City Planning Department

Memo

To: Cranston City Plan Commission
From: Joshua Berry, AICP – Senior Planner
Date: August 27, 2020
Re: “Replat Oaklawn Plat Lots 86, 87, 88, & 89” Preliminary Plan - Minor Subdivision without street extension

Owner: Richard Cardello
Applicant: Barbara Gaglione
Location: 21 Turner Avenue (AP 18-4 Lots 485, 486, 489, and 490)
Zone: A-6 (Single-family dwellings on lots of minimum areas of 6,000 ft²)
FLU: Residential 7.26 to 3.64 units per acre

SUBDIVISION PLAN

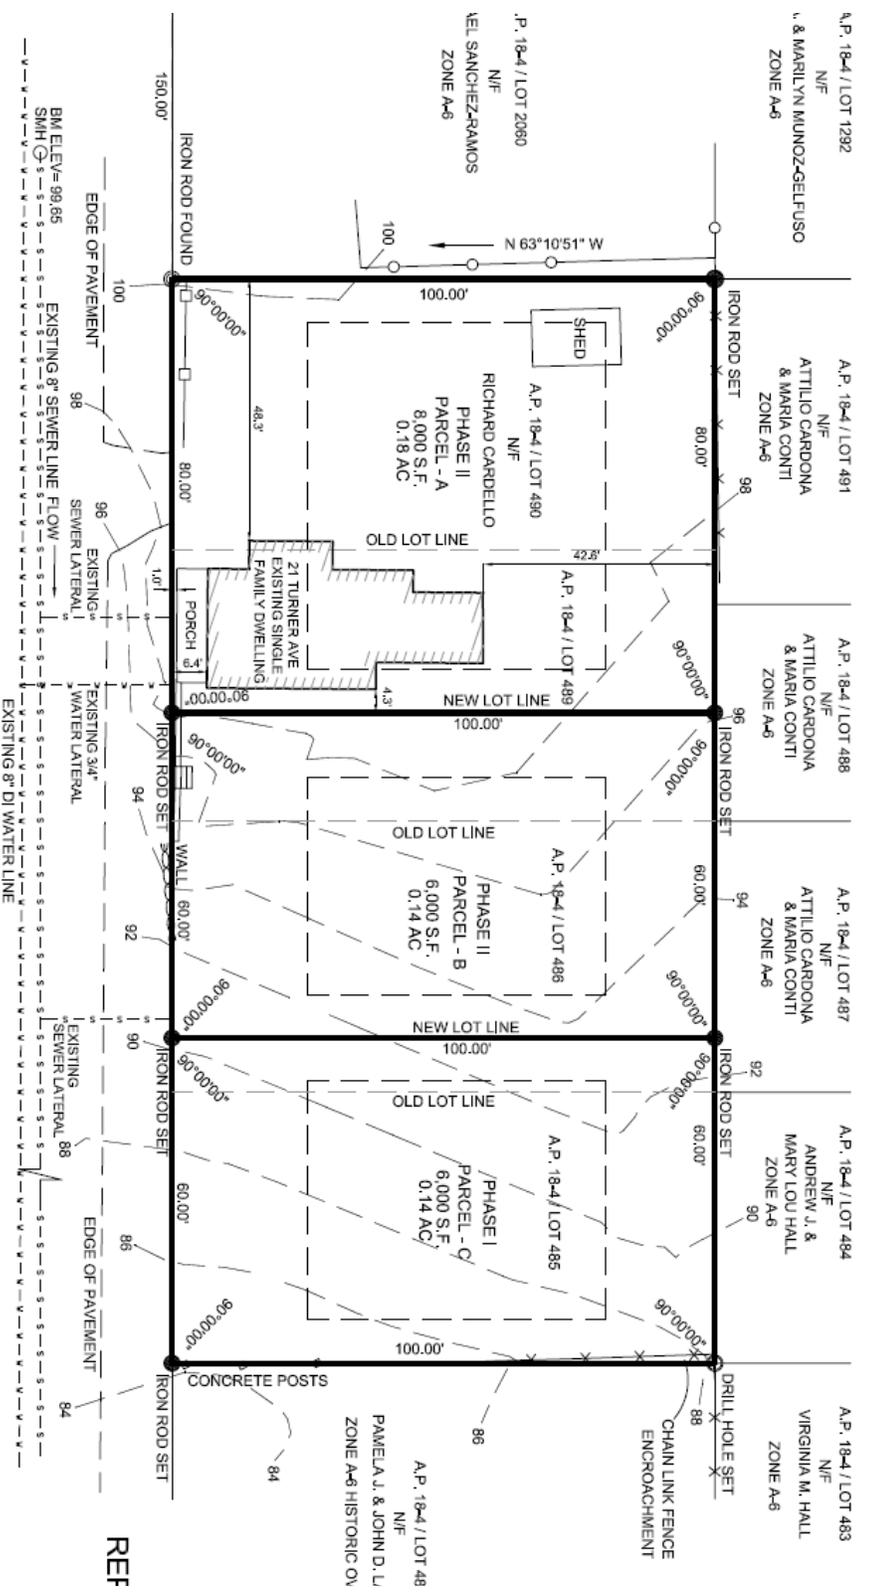
The subdivision has been redesigned from its previous version so that all of the lots now comply with A-6 zoning requirements, therefore, the subdivision of the lots is considered a “by-right” application. Importantly, the proposal is consistent the density prescribed by the Comprehensive Plan Future Land Use Map with an allocation of Residential 7.26 to 3.63 units per acre with approximately 6.53 units per acre, and the Comprehensive Plan supports housing development on infill lots in Eastern Cranston. The project site does not contain historic, cultural or natural features which would require preservation.

The proposal incorporates a few elements that are NOT by-right - the applicant is requesting waivers from the requirements for sidewalks and curbing and relief to allow the existing residence to encroach 3.7' into a newly relocated interior side setback. The sidewalk and curbing waivers are consistent with existing conditions, which was justification for the Plan Commission to grant with their approval of the previous subdivision proposal. Nothing has changed which would lead staff to change its recommendation on this matter or expect a different outcome.

The applicant is offering to self-impose a 12’ side yard setback on the adjacent lot with the shared interior lot line as to offset the impacts and prevent buildings from appearing too close together. If relief is not granted, the applicant can knock the house down and build another one, so there is no substantive difference in outcome from the City’s perspective, only the matter of whether the City wants the applicant to knock down a house and build a new one because of a 3.7’ encroachment that is being offset.

1. The applicant shall receive the necessary relief from the Zoning Board of Review for the encroachment of the existing residence into the side yard setback on Parcel A. Should relief be granted, the adjacent side yard setback for proposed Parcel B shall be 12 feet

instead of 8' feet. If relief is denied, the existing residence must be demolished or relocated as to eliminate the encroachment into the side yard setback and the side yard setback for Parcel B will be 8';
